# Access Compliance Report

## Public Rights-of-Way

Intersection ID: 46686	Main Street: GOLDFIELDS_DR	Cross Street: AYERS_ORCHARD_WY	Location: NE
ADA ID: F92FB46351D4	Ramp Type: PerpDiag	Initial Pass/Fail: Fail	Overall Compliance: No
Severity Score: 13.75			
Codes/Mitigation Info/Possible Solution		Field Measurements/Component Compliance

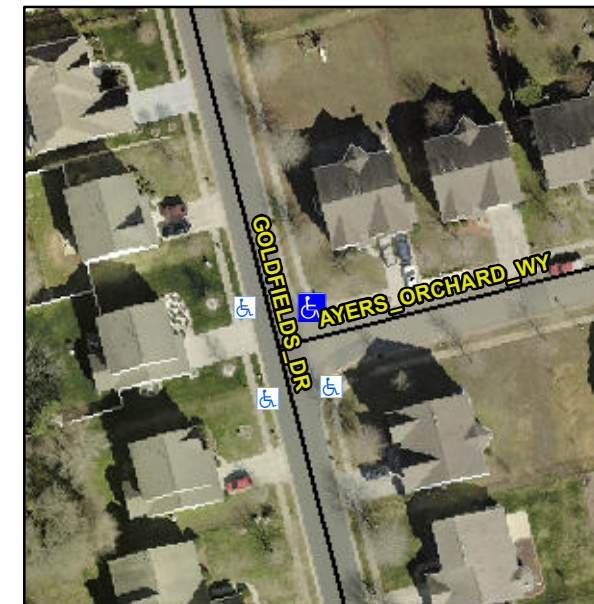
**Not Found, R304.2.2, R304.5.3**

Compliance	Description	Data	Compliance	Description	Data
N/A	Ramp Length (in)	45.0	No	Ramp Slope (%)	8.8
Yes	Ramp Width (in)	48.0	No	Ramp XSlope (%)	3.3
N/A	Flare Type LT	N/A	N/A	Flare Type RT	N/A
N/A	Flare Slope LT (%)	N/A	N/A	Flare Slope RT (%)	N/A
N/A	Flare Traversable LT?	N/A	N/A	Flare Traversable RT?	N/A
N/A	Landing Length (in)	N/A	N/A	DWS Provided?	N/A
N/A	Landing Width (in)	N/A	N/A	DWS Contrast?	N/A
N/A	Landing Slope (%)	N/A	N/A	DWS Length (in)	N/A
N/A	Landing X Slope (%)	N/A	N/A	DWS Full Width?	N/A
N/A	Landing Curb? (Y/N)	N/A	N/A	DWS Offset (in)	N/A
N/A	Shared Landing?	N/A			
N/A	Gutter Ponding?	N/A	N/A	Gutter Slope (%)	N/A
N/A	Gutter Lip Ht (in)	N/A	N/A	Gutter X Slope (%)	N/A
N/A	Painted X Walk1?	No	N/A	Painted X Walk2?	No
	X Walk 1 Direction	To W		X Walk 2 Direction	To S
N/A	X Walk 1 Width (in)	N/A	N/A	X Walk 2 Width (in)	N/A
	X Walk 1 Slope (%)	1.4		X Walk 2 Slope (%)	6.0
	X Walk 1 X Slope (%)	3.6		X Walk 2 X Slope (%)	0.2

**Remove & Replace Curb Ramp With Two New Directional Ramps or Equivalent.**
